APPLICATION NO.	FILING DATE	FIRST NAMED INVENTOR	ATTORNEY DOCKET NO.	CONFIRMATION NO.
10/804,651	03/19/2004	Tae Han Jee	060944-0200	7754
24341	7590	12/07/2005	EXAMINER	
MORGAN, LEWIS & BOCKIUS, LLP. 2 PALO ALTO SQUARE 3000 EL CAMINO REAL PALO ALTO, CA 94306			BINDA, GREGORY JOHN	
			ART UNIT	PAPER NUMBER
			3679

DATE MAILED: 12/07/2005

Office Action Summary	Application No.		Applicant(s)	
	10/804,651		JEE, TAE HAN	
	Examiner		Art Unit	
	Greg Binda		3679

Fig. 1

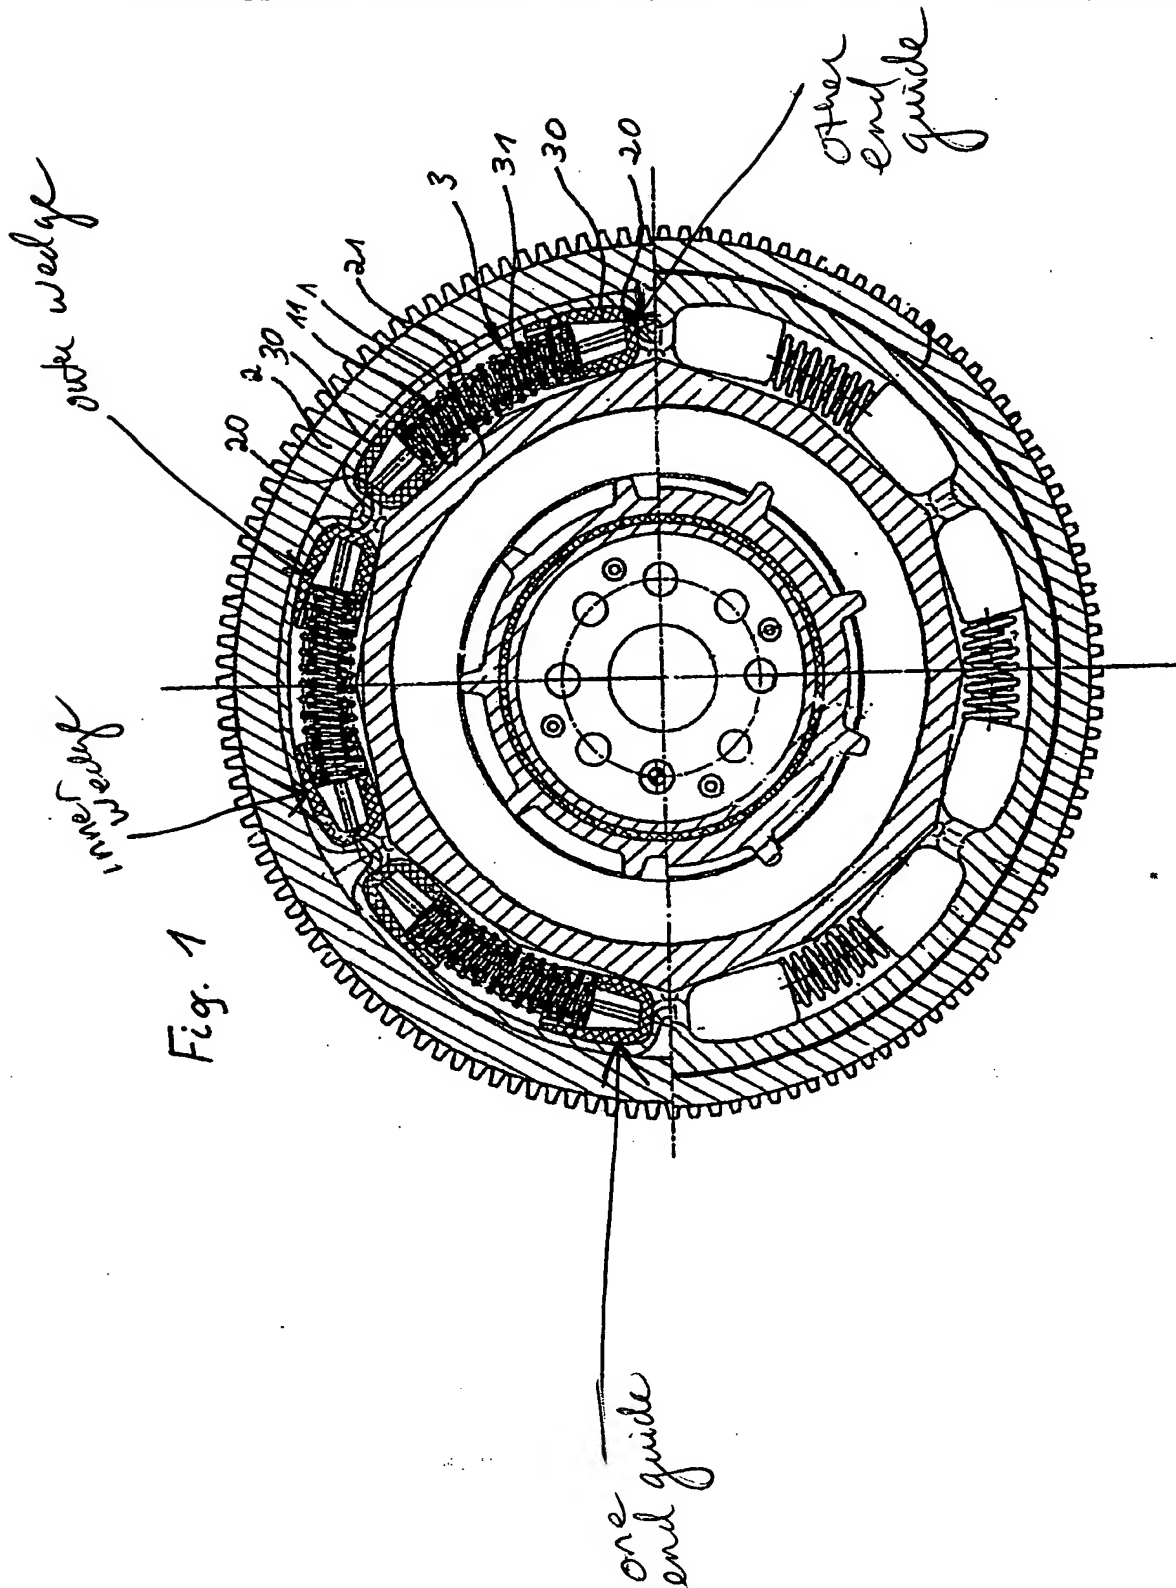
12. Claims 1, 2, 4 & 10-17 are rejected under 35 U.S.C. 102(b) as being anticipated by Rohs et al, US 2001/0046898. Fig. 1 shows a torsional vibration damper comprising: a primary mass

2 adapted to be coupled to an engine crankshaft, the primary mass defining a substantially ring-shaped chamber that is divided into at least two portions; a secondary mass 1 relatively rotatably connected to the primary mass and connectable with a clutch; and a damping unit (see the coupling elements 3) for coupling the primary and secondary masses to each other in a rotationally elastic manner. Fig. 1 show the damping unit comprises: a plurality of elastic members 31 situated in series and disposed one after the other within the divided portions of the ring-shaped chamber; a pair of end guides (see attached annotated Fig. 1) slidably disposed within each divided portion of the ring-shaped chamber and supporting outer ends of the elastic members 31; and a wedge shaped friction member slidably disposed between neighboring elastic members, the wedge-shaped friction member comprising an inner wedge and an outer wedge (see attached annotated Fig. 1). Fig. 5 shows each wedge is provide with a slanted surface 43. Figs. 7-10 show that when the slanted surfaces contact each other, the inner wedge moves inward and the outer wedge moves outward.
